Product Change Notification / GBNG-07DFNQ951

CCB 4572.002 Final Notice: Qualification of MTAI as an additional assembly site for selected Micrel KSZ9031 device family available in 48L VQFN (7x7x0.9mm) package.

CCB 4572.002
Pre and Post Change Summary
PCN #: GBNG-07DFNQ951

ANAC

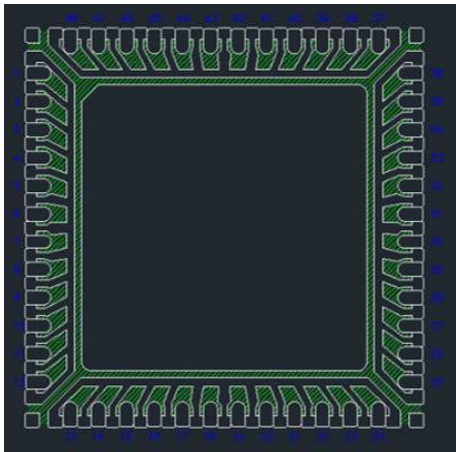
LEAD FRAME COMPARISON

Lead frame paddle size: 211 x 211 mils

ASCL

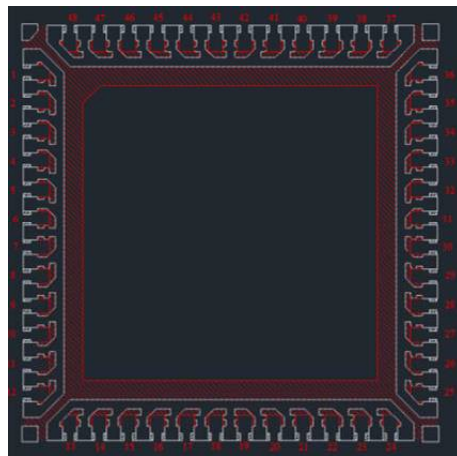
Lead frame paddle size: 244 x 244 mils

MTAI

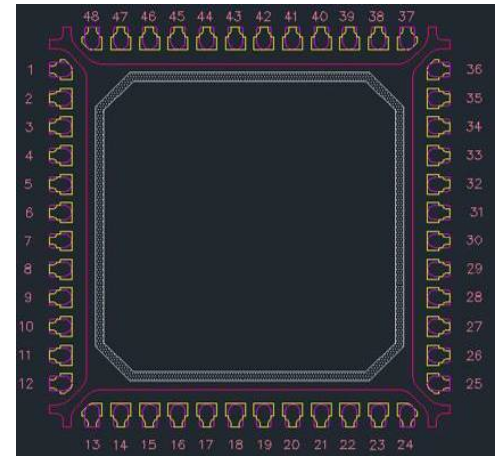
Lead frame paddle size: 244 x 244 mils
